**TASMANIA DEPARTMENT OF MINES
UNPUBLISHED REPORT 1982/49**

Examination of a proposed subdivision at Deviot Road, Deviot

by W. R. Moore

Figure 1

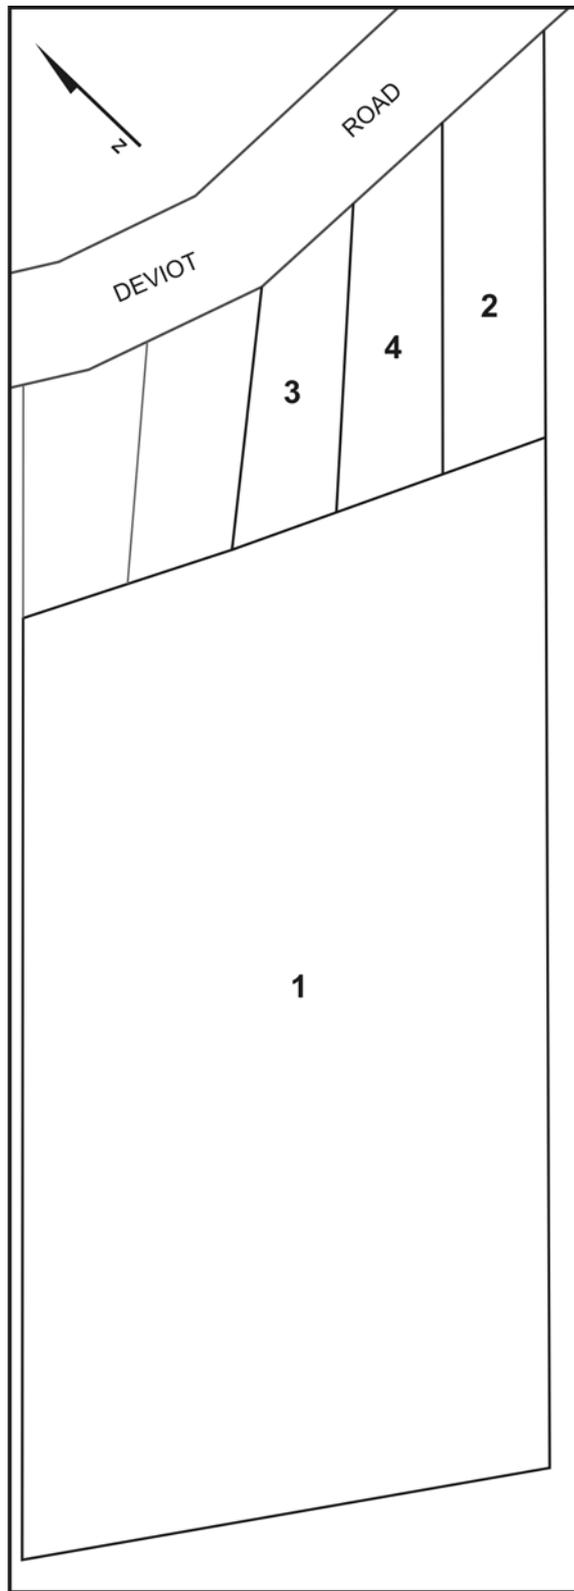
The land covered by the proposed subdivision was examined on 20 May. Only proposed lots 2, 3 and 4 (fig. 1) were examined as lot 1 was steep and scrub covered. This lot will require further examination when a contour map has been obtained, either by enlarging any existing maps or by surveying.

The three proposed lots between Bowman's house to the west and the property to the east are extremely narrow and small. In view of the difficulty Bowman is currently experiencing in confining the septic tank overflow to his property, there appears no possibility of three additional houses on the size of the proposed blocks being able to confine their overflow. At the most only one house appears feasible but severe misgivings are felt even about one house.

The blocks form a natural depression into which all the surrounding surface water collects. In winter much of the area is under water. Draining the area without putting the water onto the road appears unlikely. The road in front of these blocks currently shows severe cracking, with the cracks spreading across the road towards the River Tamar. Some of these cracks have been filled with bitumen but have cracked again. These tension cracks are strong evidence of potential failure and give a general indication of the general instability of the locality.

Even though the slopes are low on the front blocks the addition of more water through septic tanks and additional weight can only make worse what is already a bad situation. Failure of Deviot Road is likely, as has already occurred to the south. It seems very likely that Bowman's sullage overflow added or contributed to the road cracking.
